PERMIT NUMBER: B 22002743

RESIDENTIAL BUILDING PERMIT APPLICATION

PERC CERTIFICATION PLAN
14700 CARRIAGE MILL ROAD
LOT 1 PHASE 1 CARRIAGE MILL FARMS
PLATS 12211-12215 TITLE REF: 4300346
TAX MAP 50, GRID 10, PARCELS 150
4th ELECTION DISTRICT, HOWARD COUNTY, MD
SCALE: 1" = 30' DATE: 05/25/22

PROJECT: **DORSEY RESIDENCE HOME ADDITION**

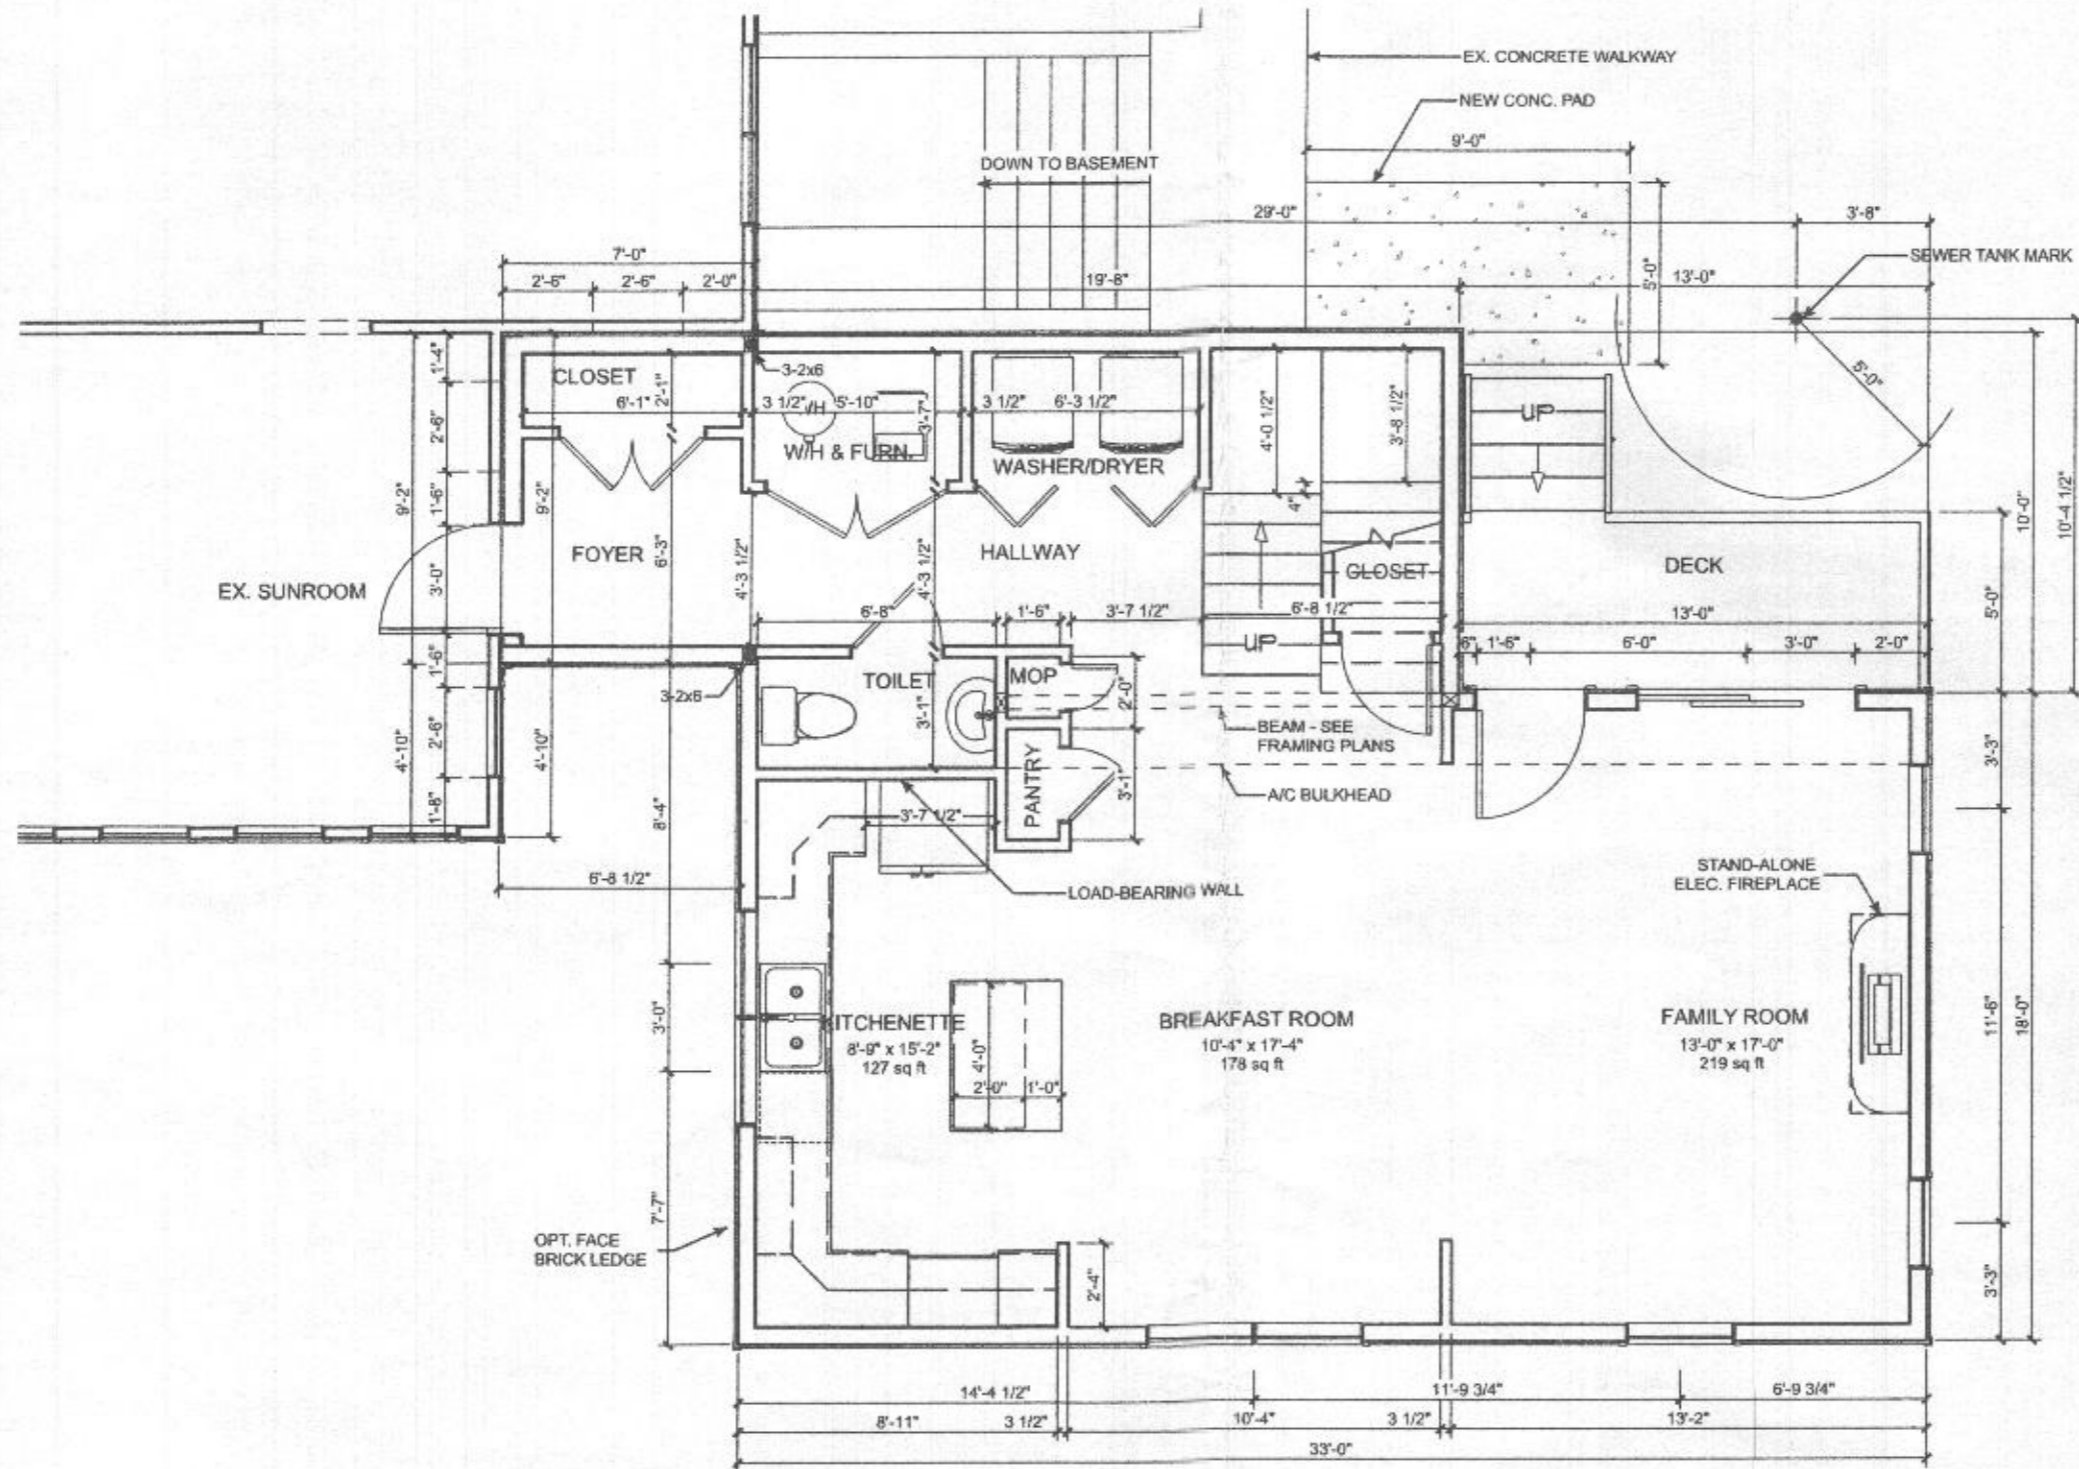
- Show perc test hole locations in support of the revised SDA shown on plan. Additional perc testing may be required. Need to see test hole locations.
- Show elevation # next to each test hole.

- Both ends of the trenches will need to be field located and shown accurately on the plan.
- Add note to indicate that the septic system components have been field located and are accurately shown.

- Add note to indicate that the well has been field located and is accurately shown.
- Show a well box or 2 alternate well sites.
- The existing trenches are good for 5 bedrooms.
 $103'L + 94'L = 197'L \times 2'W = 394 \text{ sq. ft.} / 0.36 = 1094 \times 0.8 = 875 \text{ gallons} / 150 \text{ gallon} = 5.83 \text{ BRs}$ [Sidewall = $2 + 2 / 2 + 1 + 2(4) = 0.36$]

I received the test plan for 14700, and it only shows one field located perc test hole. Is this a proposed perc test hole location? The record shows 4 passing test hole locations (31A-31D) for the existing sewage disposal area. Please show these 4 test holes on the plan. We will want to dig at least one test hole in the center of the SDA, and one perhaps where you are already showing test hole #1 to see if the soils are consistent. If the soil is not consistent, then more test holes will likely be needed. Well also need to field locate the trench ends.

Please update the test plan per comments and submit a couple copies. Once I have the new test plan, I will reach out to you and the homeowner to schedule the perc test. The existing perc test holes plus proposed test holes will need to be properly field located and staked prior to the test date. A septic contractor with a backhoe capable of digging a hole to at least 13 feet will be required.

DRAWING: **SECOND FLOOR PLAN - NEW**
 SCALE: 3/16" = 1'

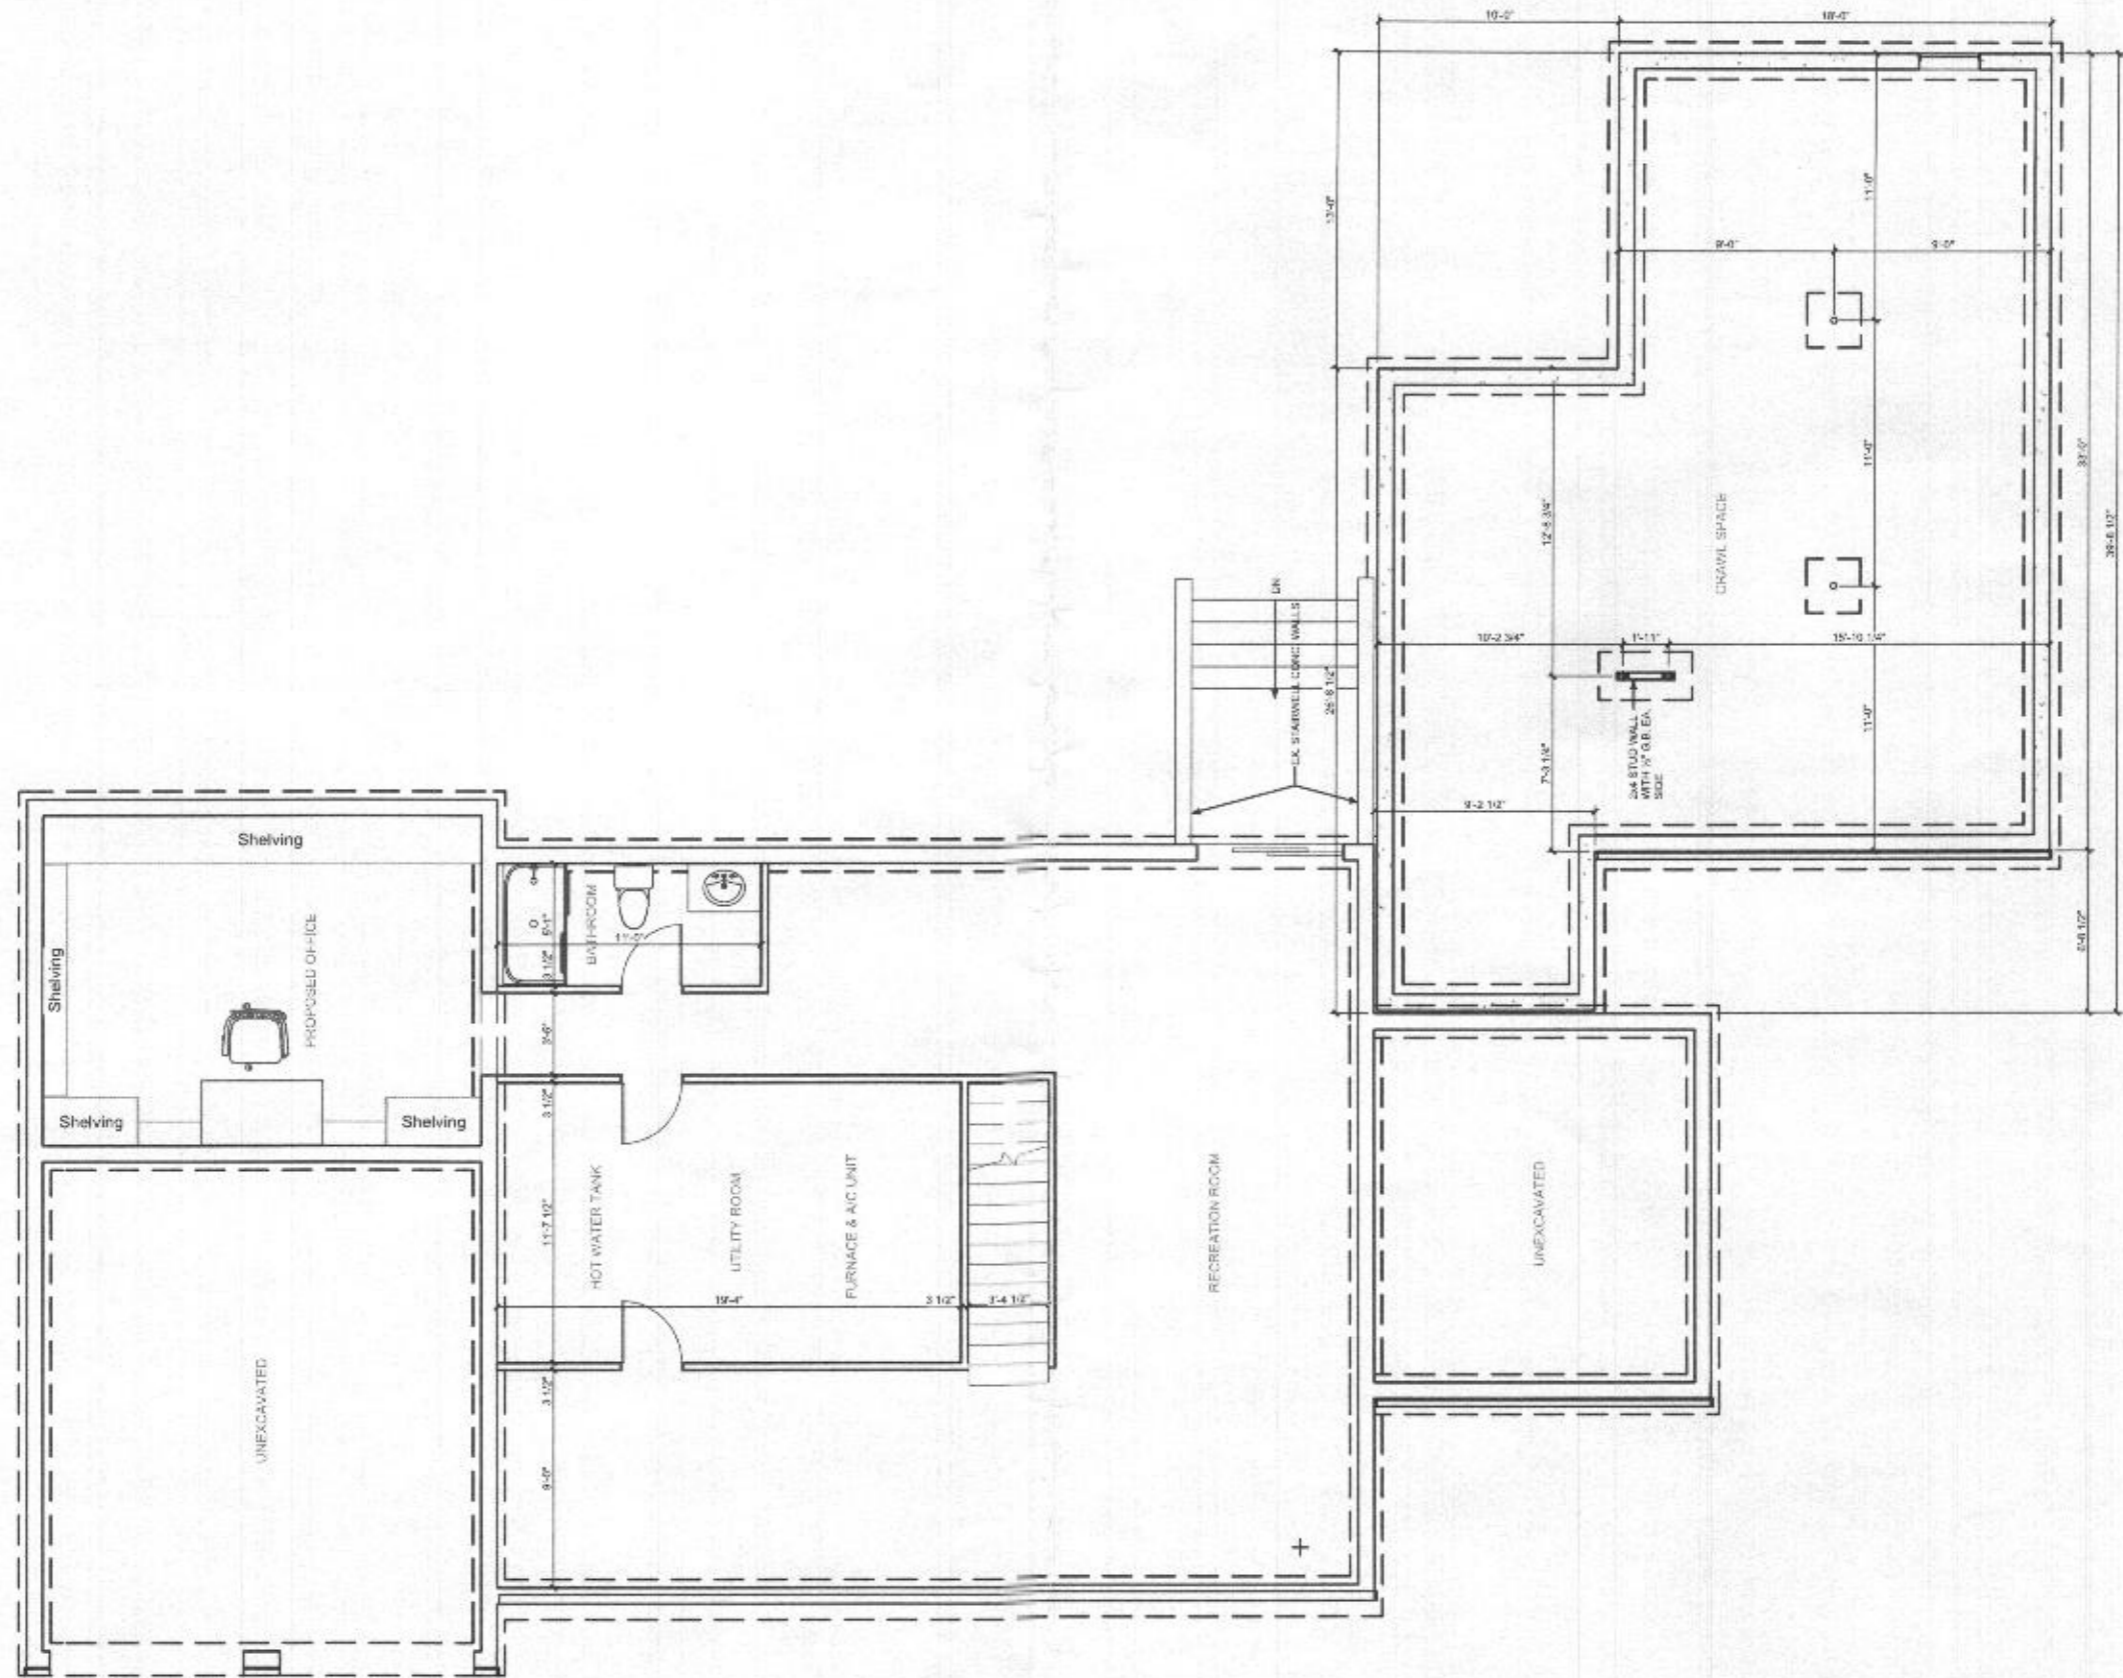
Good morning. I received the revised floor plans from permits office for the changes to the proposed addition and existing basement bedroom. The floor plans for the proposed addition still shows the 3'-9" opening into the "office" on the 2nd floor (see attachment). The opening into this area needs to be at least 4'-0" wide, so that it doesn't meet the definition of a bedroom. It should also read, "4' wide cased opening without a door". In addition, it would be nice if the basement bedroom floor plan spelled out "permanent shelving units/desk" in the room on the plan.
